Fort Ord Regional Trail and Greenway Project, Canyon del Rey/SR 218 Segment

Addendum to the Environmental Impact Report

September 2021

Figure 2 Modified Project Revised Trail Alignment

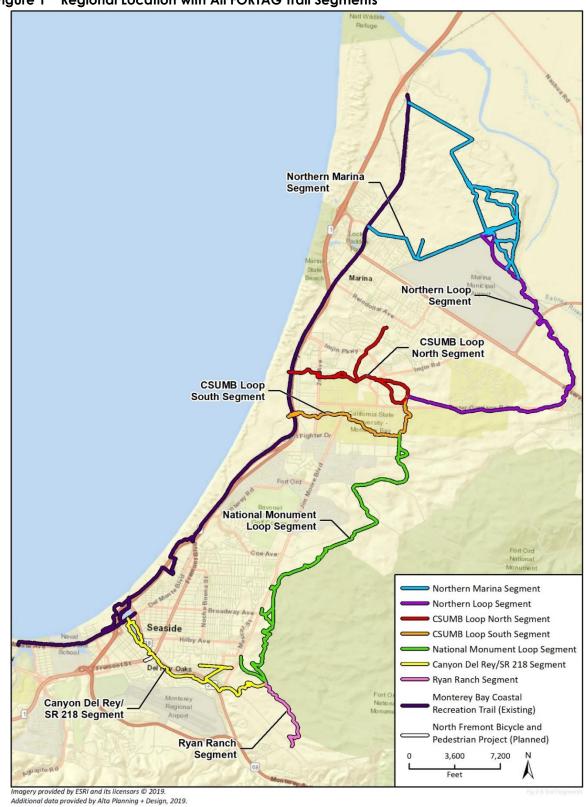
- The portion of the Trail adjacent to the tennis courts in Work Memorial Park would be moved from the southwest side of the tennis courts to the area north of the maintenance walkway, as illustrated in Figure 2. It would be situated in the elevated, vegetated area supported by the existing retaining wall, which would be kept in place or replaced with a similar structure. See the inset photographs in Figure 2, particularly the one labelled "east site looking west."

- Crossing locations would be added at Plumas Avenue at its intersections with Waring Street and Noche Buena Street to improve Trail access. Curb ramps would be modified to meet current ADA requirements.
